ABINGTON TOWNSHIP

PLANNING COMMISSION MEETING

a. Motion to approve the major LD-22-02 Huntingdon Valley Shopping Center (Chipotle Pad Site)

b. Motion to approve the major subdivision LD-22-03 - Autozone located at 1318 & 1330 Easton Road.

DETAIL: 29

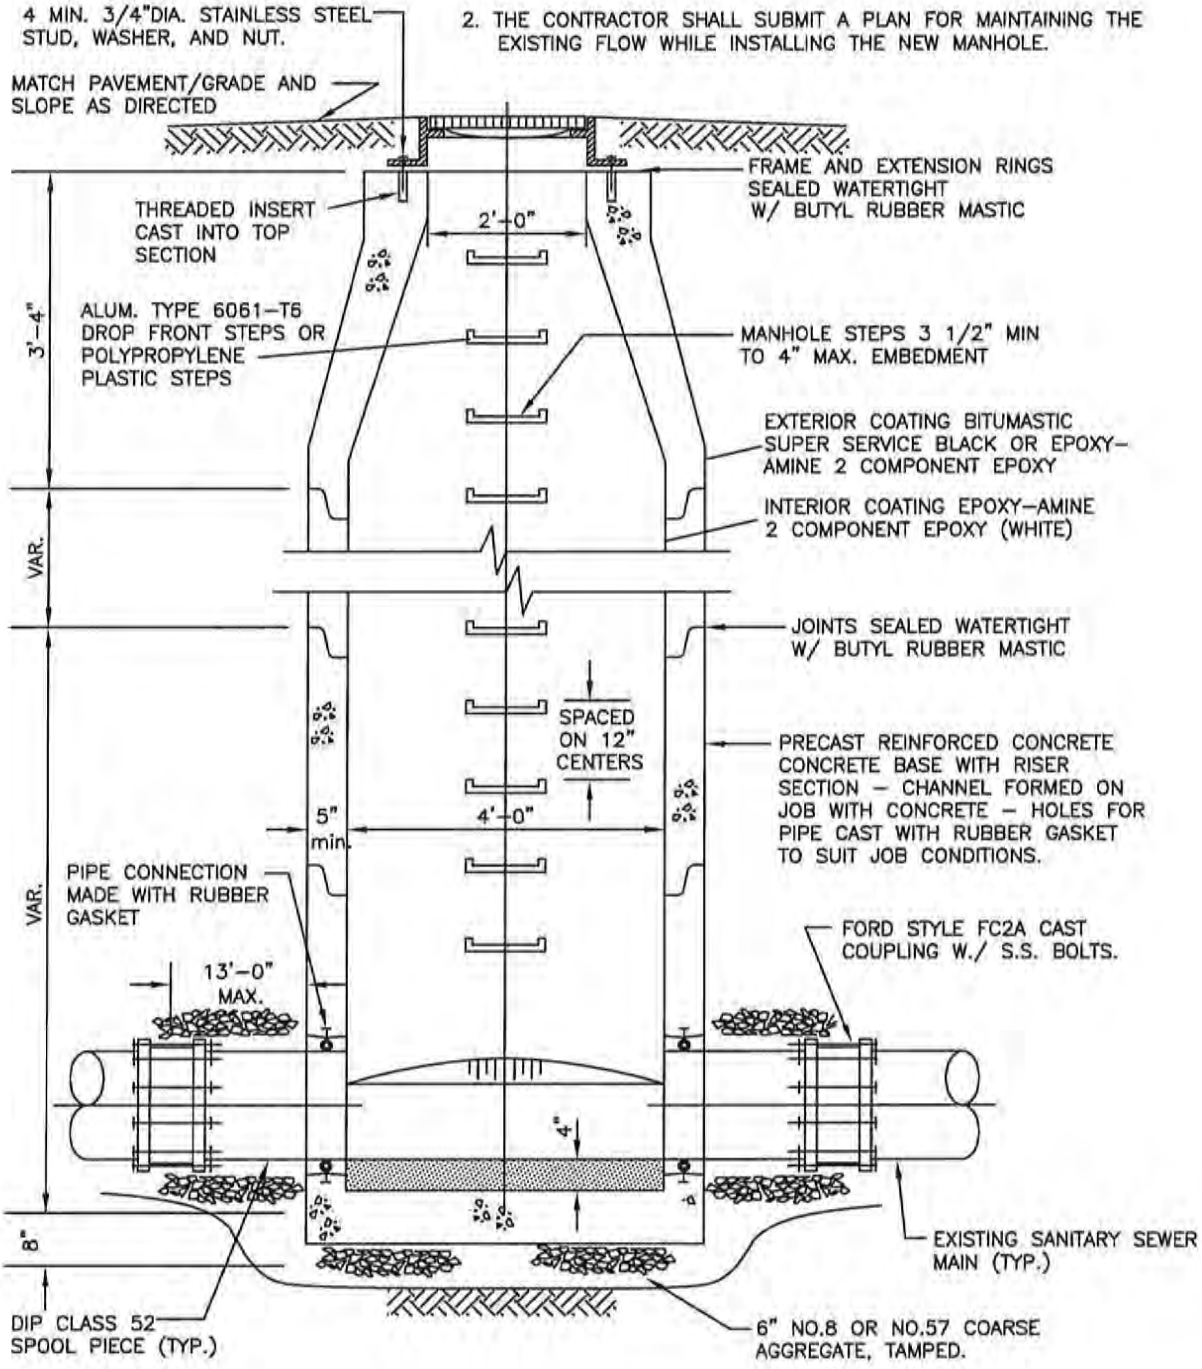
1) Sheet No.6 of 14 "Utility Plan": The proposed new Chipolte Restaurant shall be connected into the existing sanitary sewer system by installing a four (4) foot diameter precast insert manhole (see enclosed Detail No. 29) into the existing sanitary sewer line located south from the Citizens Bank, which is routed through the vacant parking area adjacent to Crunch Fitness to the rear of the shopping center. An eight (8) inch diameter ductile iron pipe should be routed from this inserted manhole north into the Chipolte site and terminated with a four (4) foot diameter precast concrete manhole with an 8" stub for future connections, as indicated on the enclosed marked up plan.
